October 20, 2023

Re: Alteration to "Westridge Addition of Westridge PUD" Final Plat File # Z23-180FPLT

File No: Z23-108FPLT

Subject: Alteration to Westridge Addition of the Westridge PUD (Z9700042-FP, document recording no. #4223669)

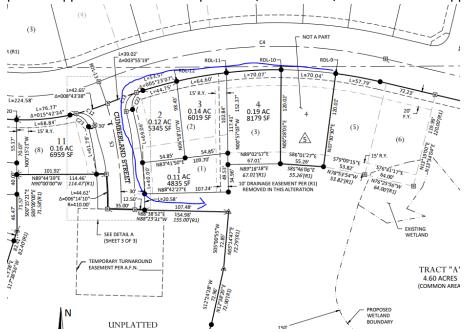
- VII. Engineering will continue to review the proposed modification to the existing stormwater easement near proposed lot 1 block 5. As per follow-up response the on 10/16/ and 10/17/23, the grade of the road has/will be changed resulting in stormwater flow as depicted in the image below. Engineering approval of this modification to the stormwater easement will be required prior to approval of revised civil plans and/or final PUD/Plat Amendment approval.
